COVER SHEET
C0.0
1 of 53 Sheets

EAST TOWN CROSSING PHASE 1

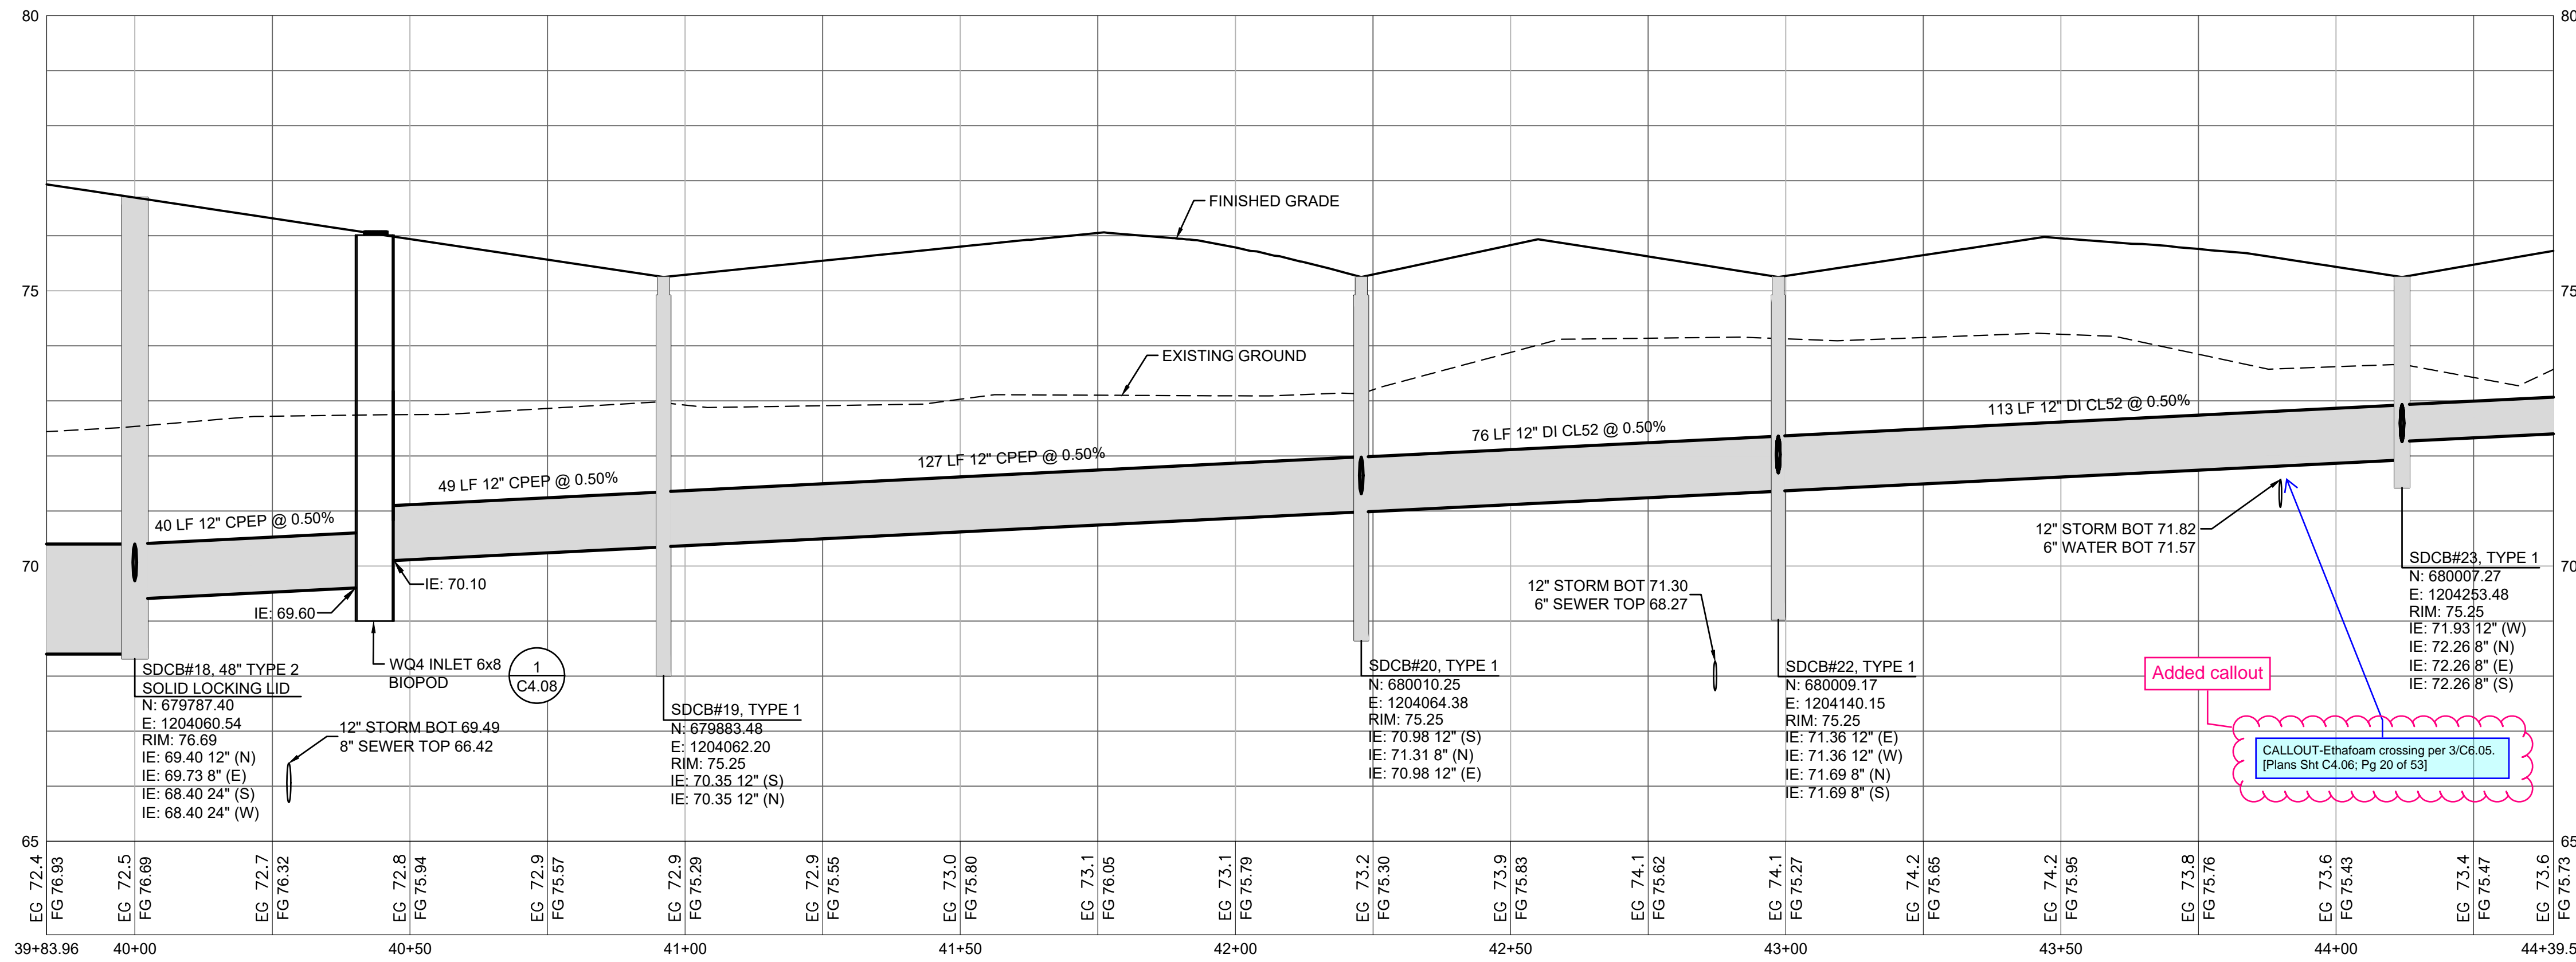
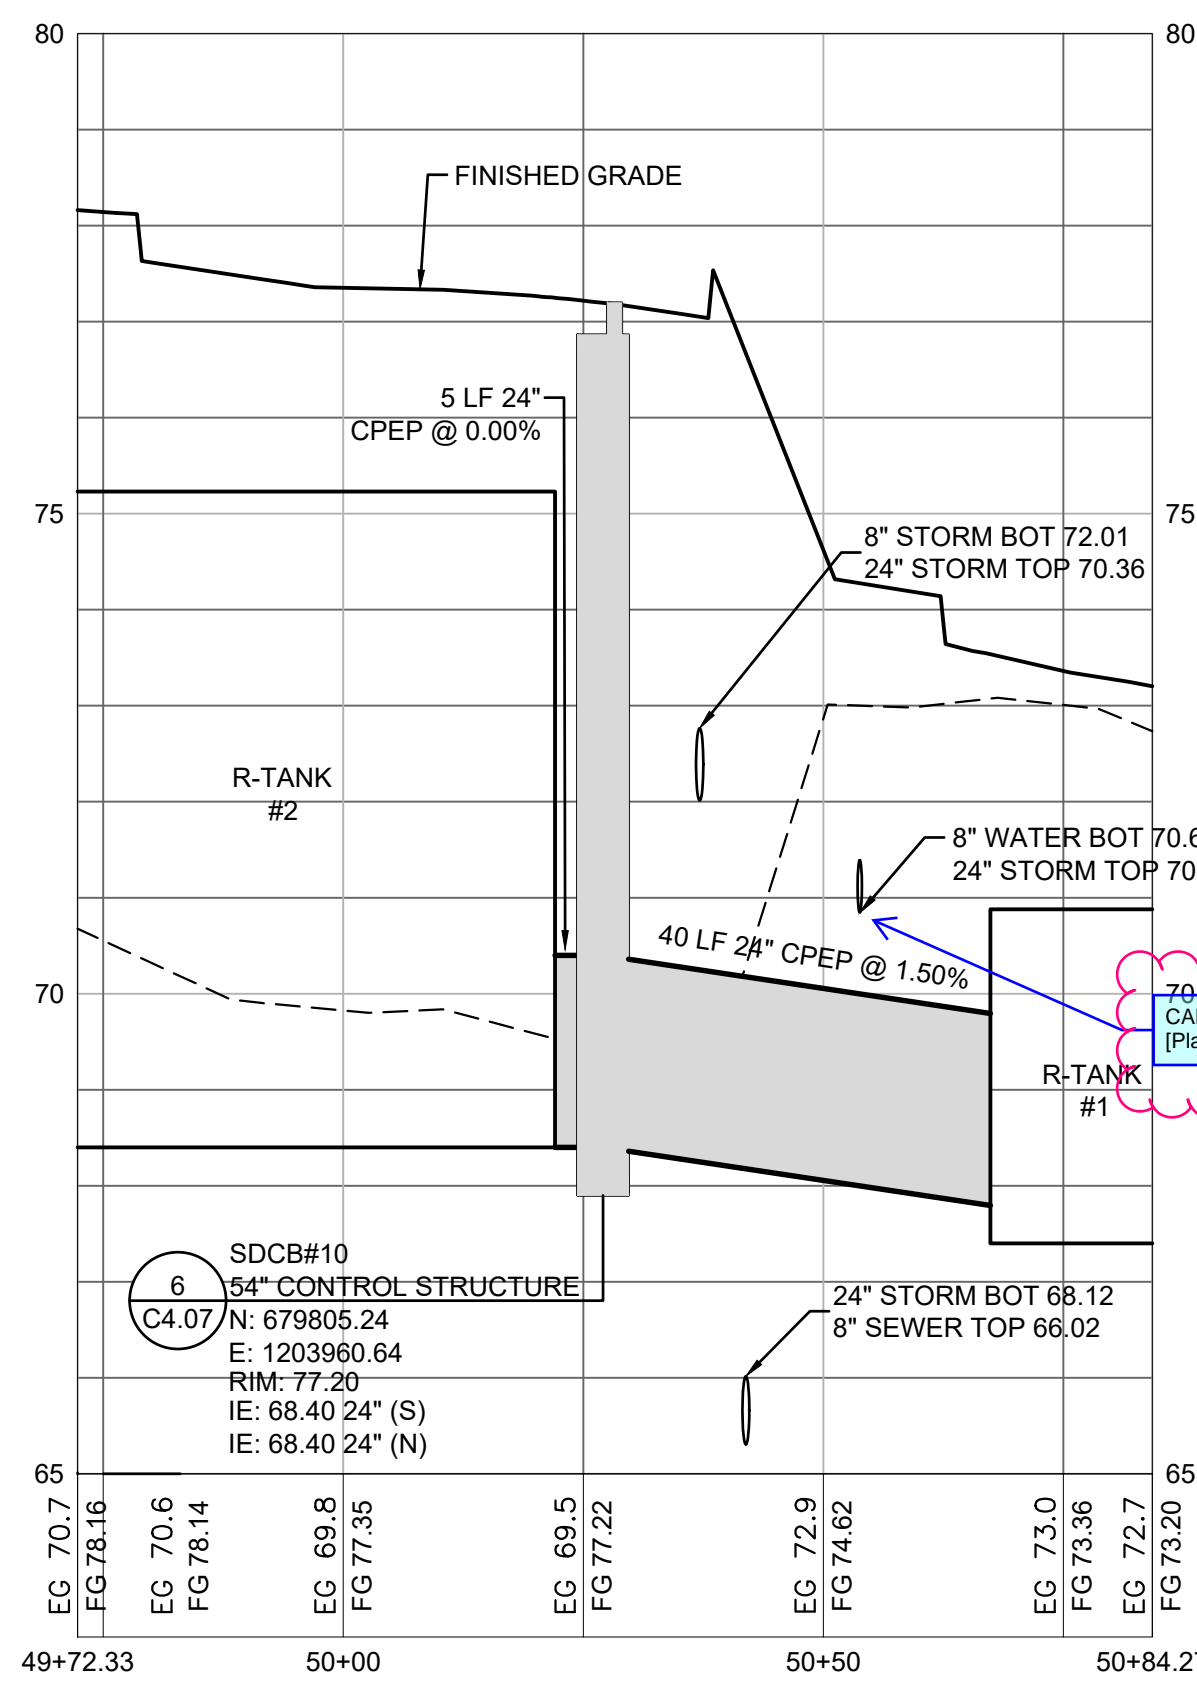
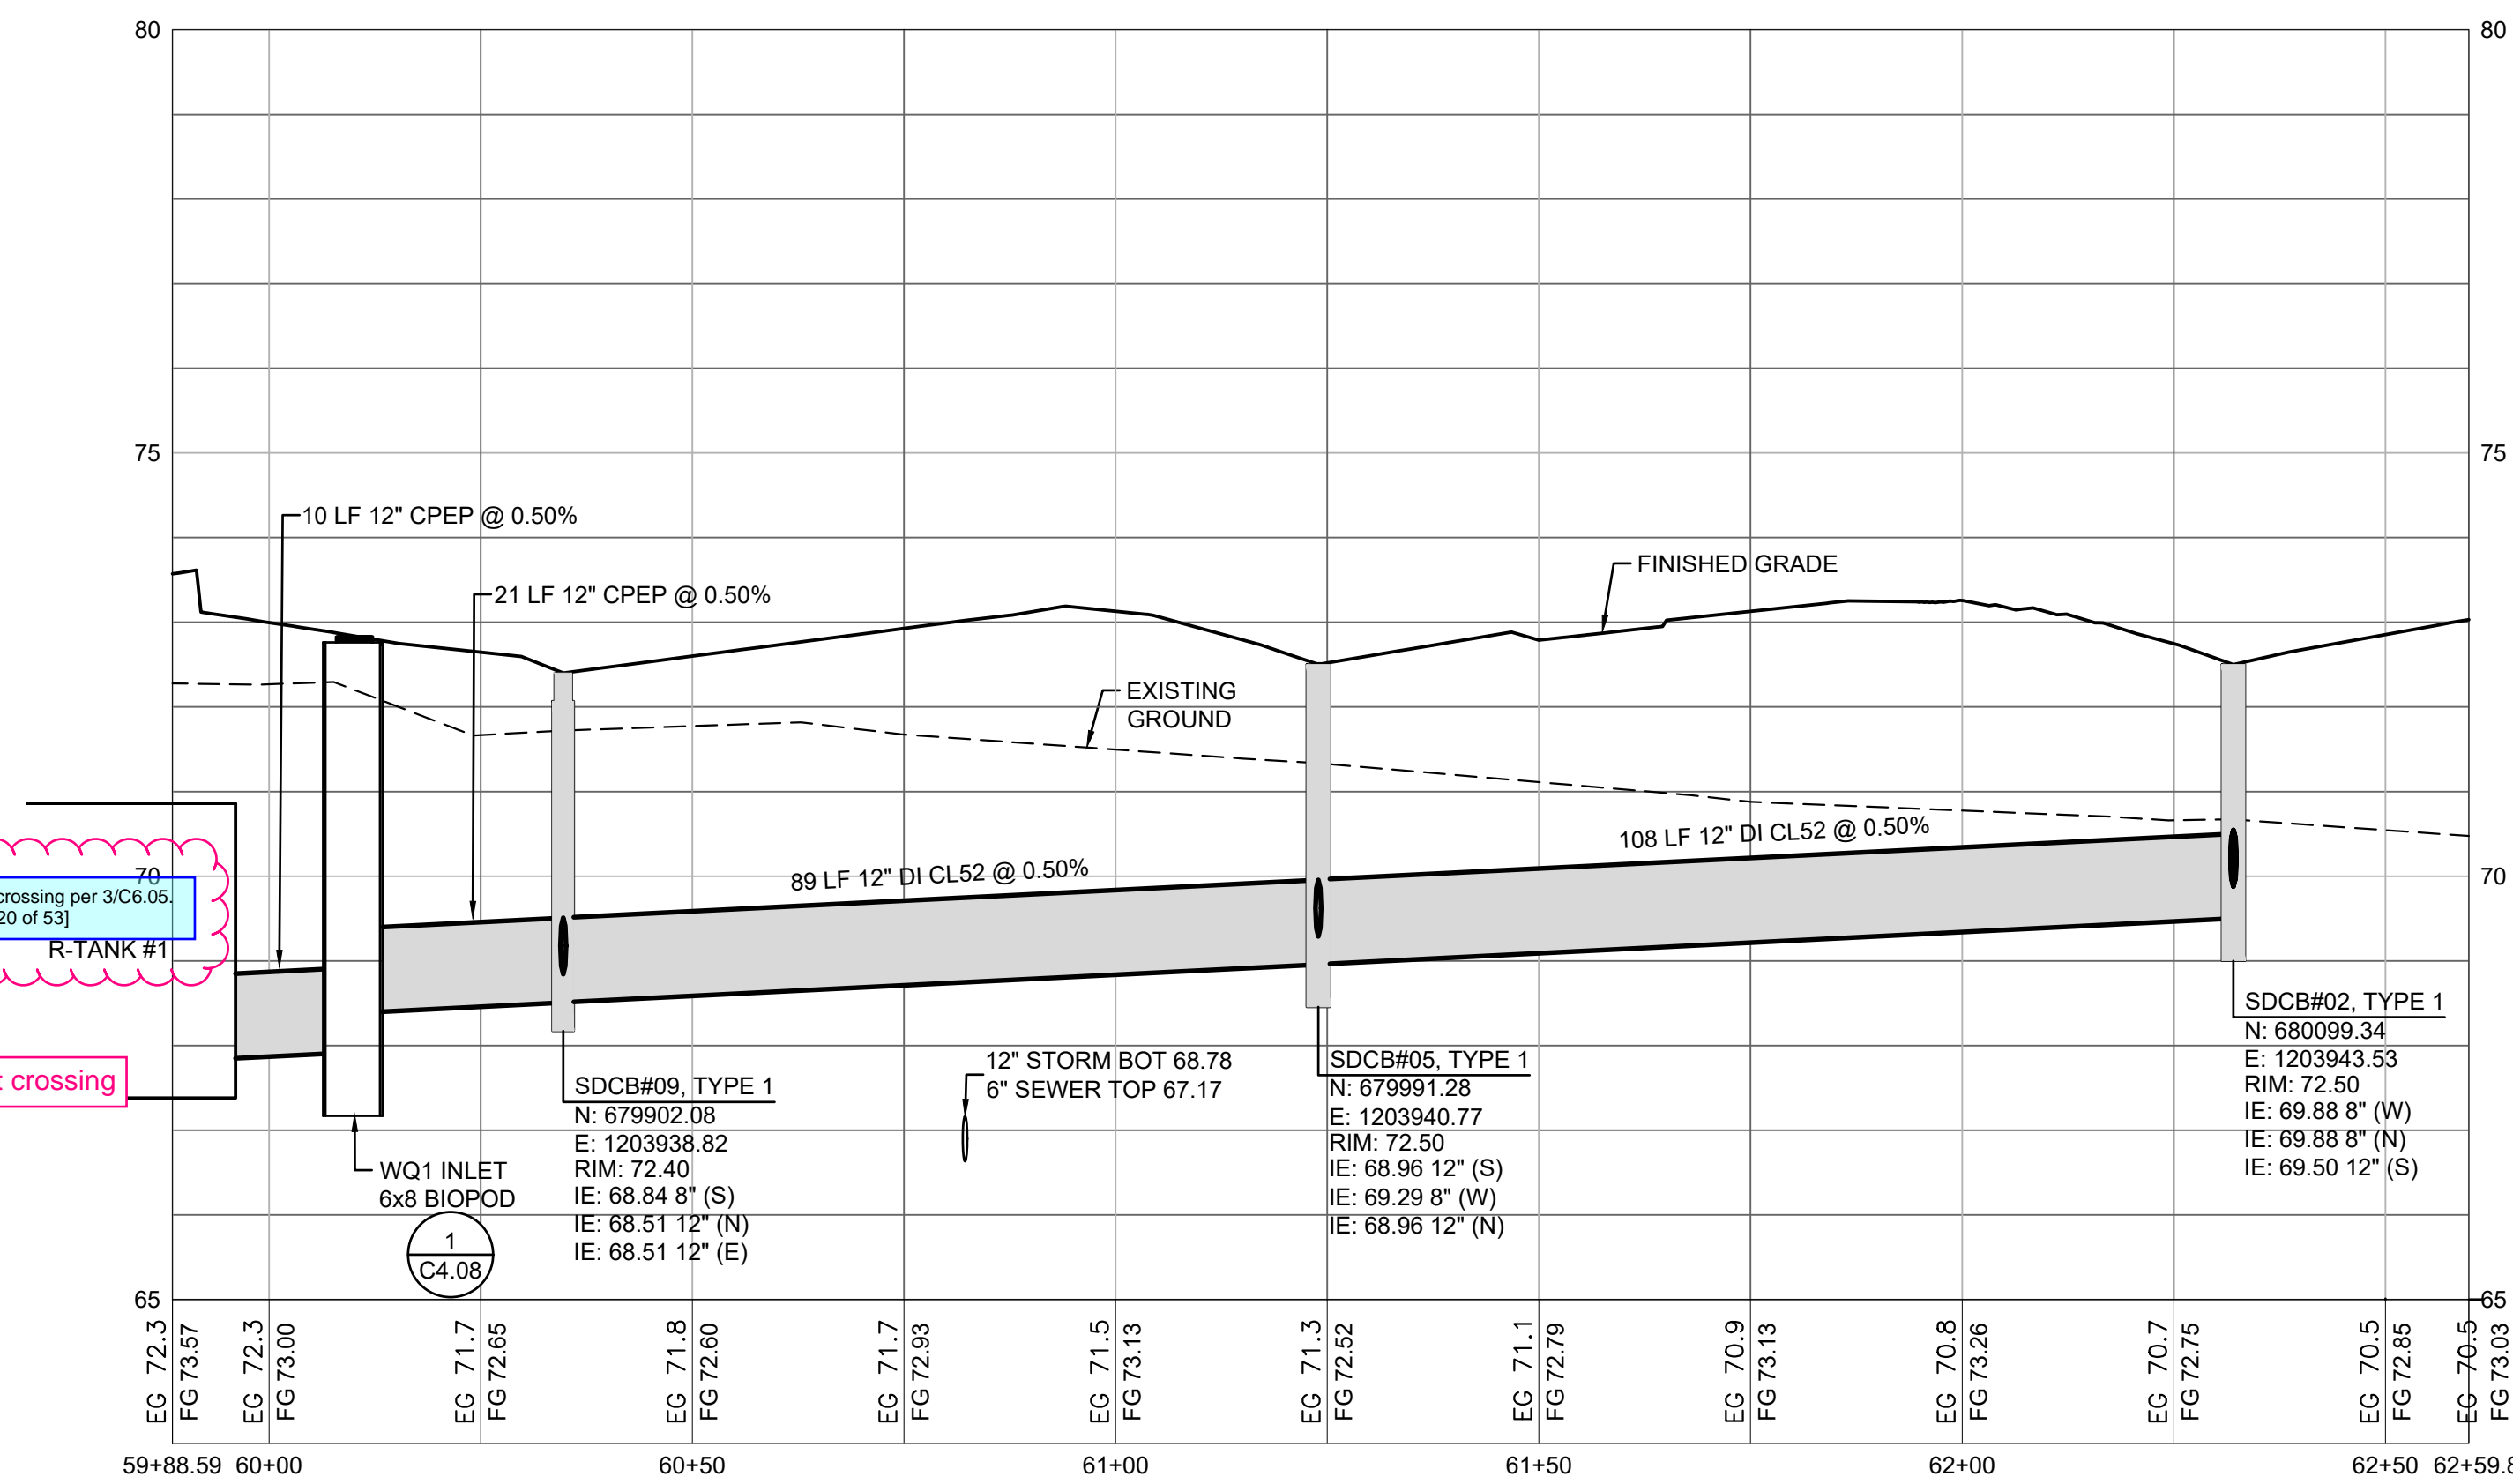
CALLOUT: Ethafoam crossing per 3/C6.05, [Plans Sht C4.06; Pg 20 of 53]

CALLOUT-reference, [Plans Sht C4.06; Pg 20 of 53]

Added callout
